**LEVY NUCLEAR PLANT, UNITS 1 AND 2
DOCKET NOS. 52-029 AND 52-030
PARTIAL RESPONSE TO NRC RAI LETTER 116 – SRP SECTIONS 6.3 AND 15.2.6**

**Levy Nuclear Power Plant Units 1 and 2
Response to NRC Request for Additional Information Letter No. 116 Related to
SRP Sections 06.03 and 15.02.06 for the Combined License Application, dated March 6,
2014**

Westinghouse Nonproprietary Class 3
Responses to NRC RAIs 06.03-1 and 06.03-6 on Condensate Return

Figure 7 – IRWST Level Comparison

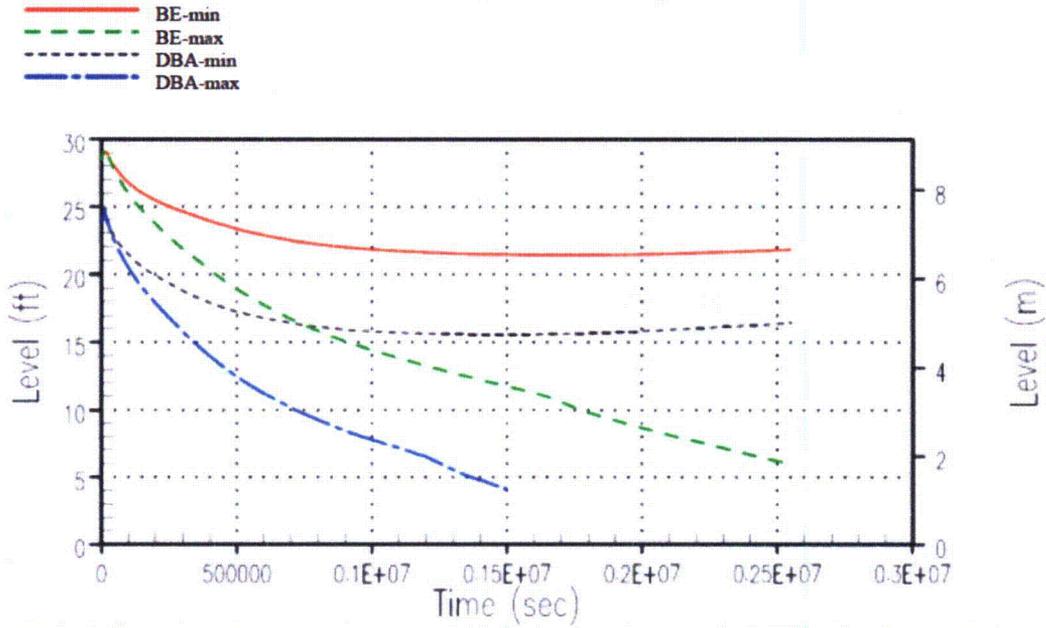
However, the submittal itself does not describe how each of the above phenomena was modeled and what values were used for the input and boundary conditions. For the staff to make a safety determination on PRHR heat exchanger with respect to General Design Criteria 34 of 10 CFR Part 50, Appendix A, please provide the following regarding APP-PXS-M3C-071 as response to this RAI:

- a. Complete listing of important phenomena modeled. For example, the effect of steaming from reactor vessel bottom head by condensate accumulated in the reactor vessel cavity was credited but not noted in the submittal.*
- b. Description of phenomena and methodology used to analyze the phenomena.*
- c. Values of input and boundary conditions and justification of the values used. Important assumptions used and their justification.*
- d. Results of the calculations.*

Figure 7 presents a comparison of the IRWST level response for the 4 transient cases. The IRWST levels for the upper bounding spill rate cases decrease at a much faster rate than the lower bounding spill rate cases and do not equilibrate. The level that is shown in this plot is based on the water volume in the IRWST, as modeled, and is not representative of the actual IRWST water level.
